Reading Conservation Area Advisory Committee
6 September 2024

**OBSERVATIONS ON PLANNING APPLICATION AND LISTED BUILDING CONSENT 240874 &
240875 33 BAKER STREET**

Figure 5 Section of lost railing as it was in June 2018 (Google streetview)

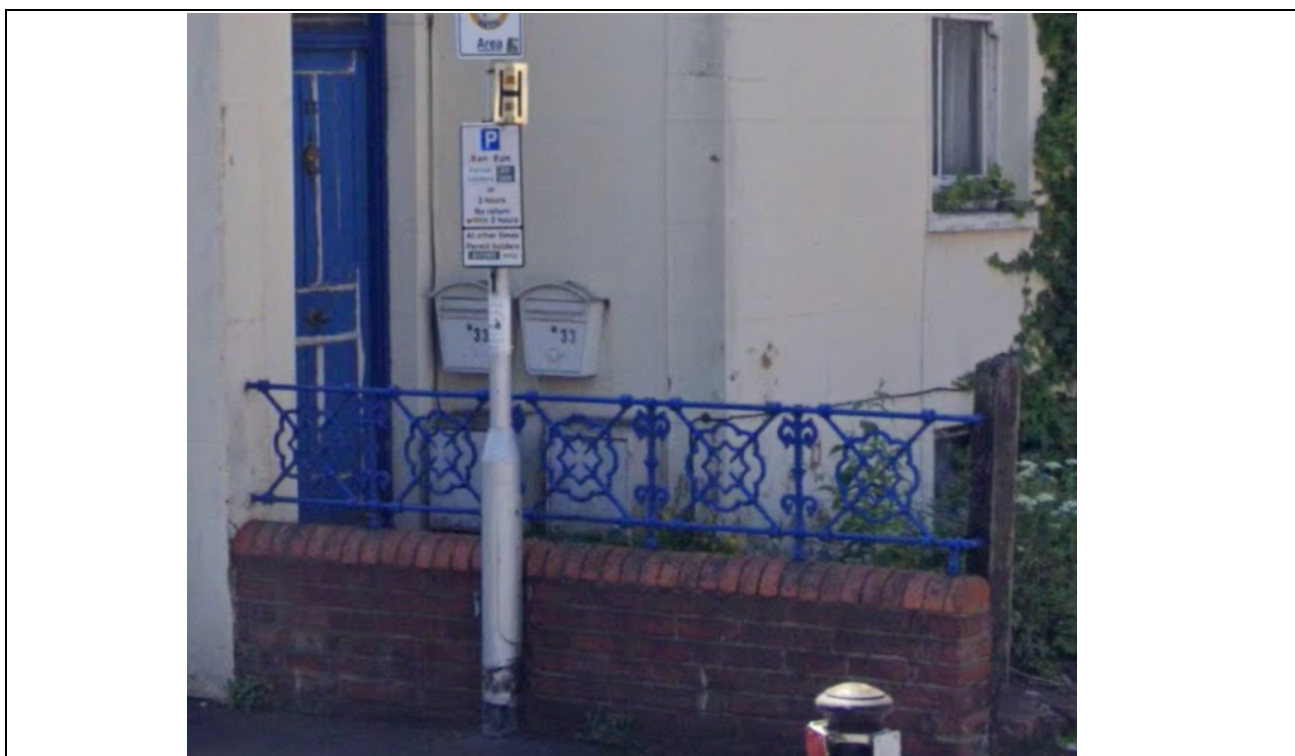
1.2.3.5 Railings. The loss of a section of original railing is lamented (see image below). We note that the applicant intends to install a railing along this wall and request that a railing is also re-instated at the front of the property along Baker Street. The railing to be installed has not been specified by the applicant but materials and style should be secured by condition. Railings or a grille will be required to prevent falling in to light wells and these should also be specified and materials and style secured by condition.
